MEMORANDUM

SUBJECT: BZA Case 18975 - application for a special exception from the roof structures requirements under § 411.3, to allow the screening of rooftop mechanical equipment for a proposed food manufacturing use at premises 2619 Evarts Street N.E.

Location of Existing Rooftop Mechanical Equipment

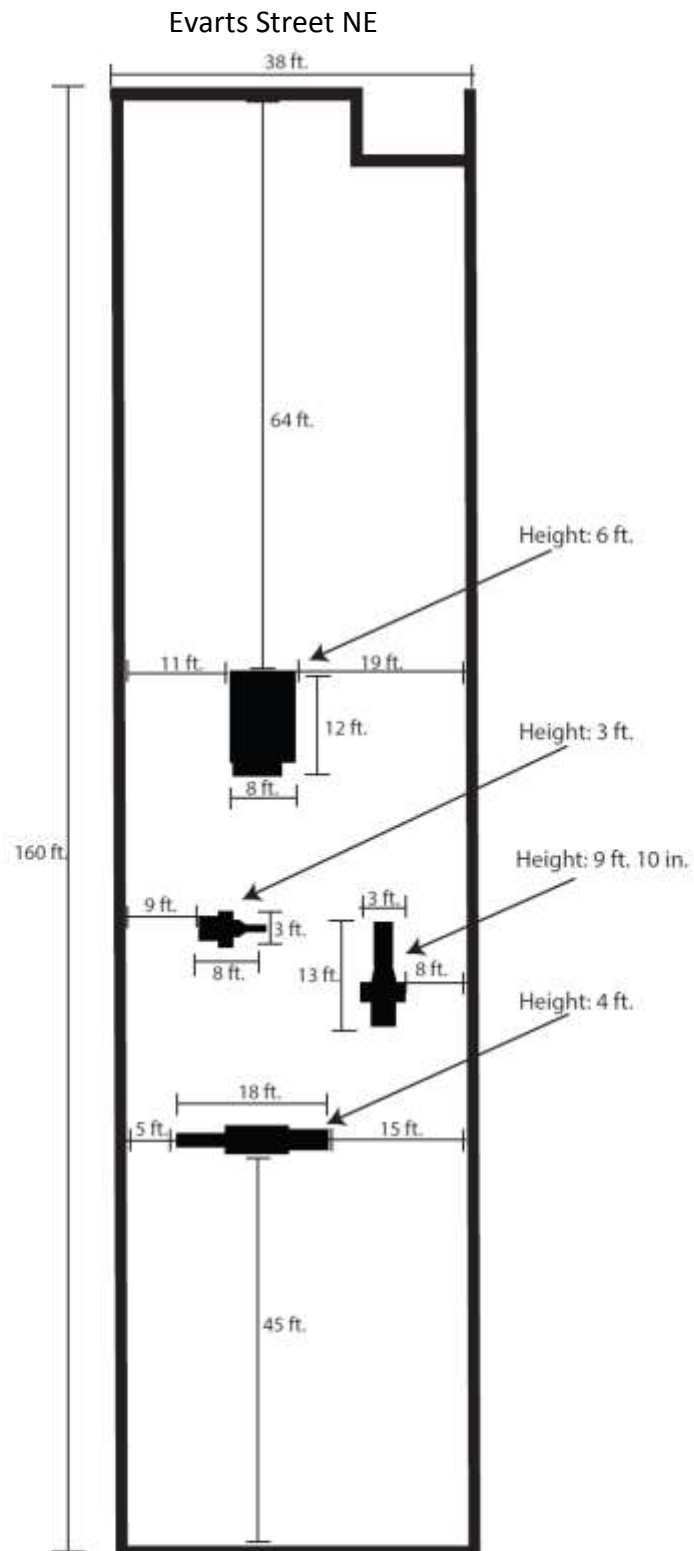
Typically, OP supports the screening of mechanical equipment consistent with § 411.3; however, photographs provided by the Applicant, and confirmed by a site visit by OP, demonstrate that the Subject Property's existing rooftop mechanical equipment is largely out of public view. Further, elevations submitted by the Applicant also demonstrate that there are no sightlines to the mechanical equipment at a pedestrian level from across Evarts Street NE to the north. The Applicant maintains, and OP agrees, that in this instance screening for existing mechanical equipment, which OP estimates would have to be at least 50 feet by 25 feet in area to encompass all of the mechanical equipment, could potentially raise the equipment's visibility. The immediate area is predominantly comprised of industrial uses.
